Jason,

A quick look and it seems ok.

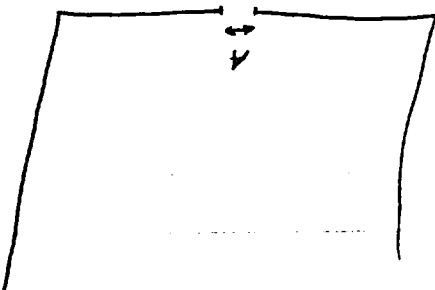
However, you assume that there is
no loss at the break (hole). This
loss could be significant. This only
makes your results a little conservative
so I don't see a big problem.
